Official Transcript of Proceedings
NUCLEAR REGULATORY COMMISSION

Title: Advisory Committee on Reactor Safeguards
Reliability and Probabilistic Risk Assessment

Date: Wednesday, September 23, 2020

The Integrated Human Event Analysis System (IDHEAS) Program Introduction

IDHEAS-ECA's HRA Process

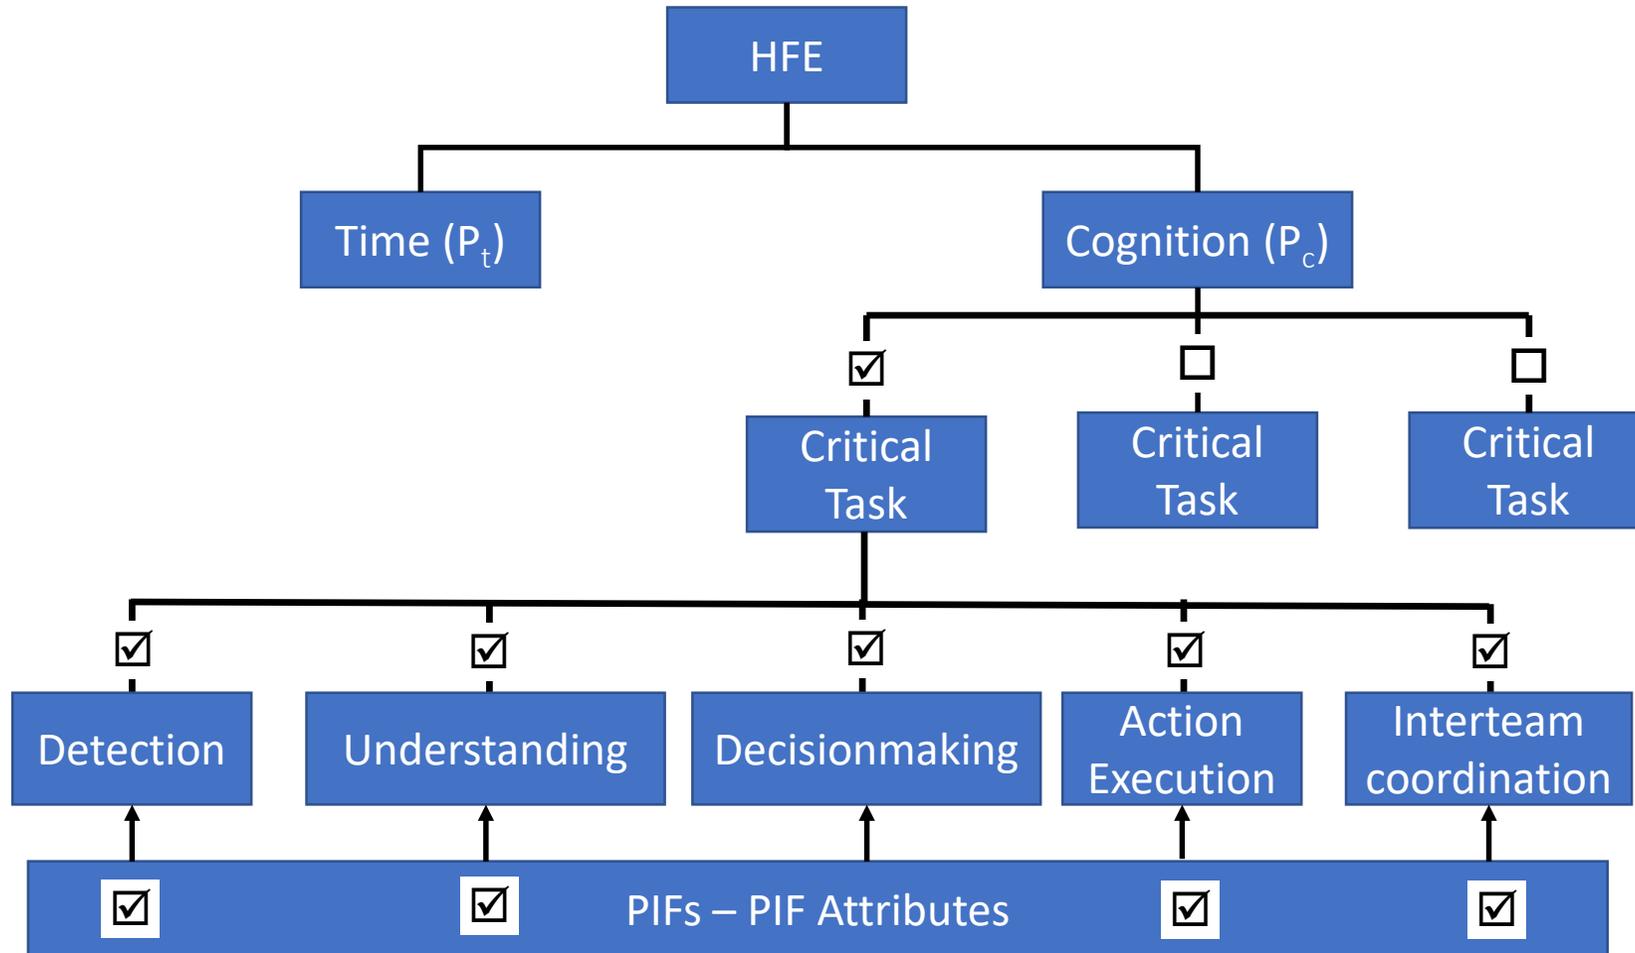
22 MEMBER REMPE: James, before you leave
23 that prior slide. When I was looking at your report,
24 as well as seeing this figure here, I was puzzled why
25 you don't show Step 8 on this diagram, which is

1 related to assessing uncertainties. And as emphasized
2 in the last presentation, ACRS often emphasizes the
3 importance of considering uncertainty analyses in such
4 an evaluation and a process. And so I'm not only
5 bringing that point up here for your presentation, but
6 it's a point I would like to see considered before you
7 finalize this report that you ought to explicitly note
8 all eight steps in this figure.

13 MEMBER REMPE: Right. And you even say in
14 the report, not shown in the figure. Well, why not?
15 Go ahead and please put it in the figure. Okay?

9 MR. CHANG: Yeah, thank you. Yeah, we
10 discussed that Step 8, I'm certain in the report. I'm
11 not showing in the figure. We will modify the figure
12 to include the uncertainty in the process.
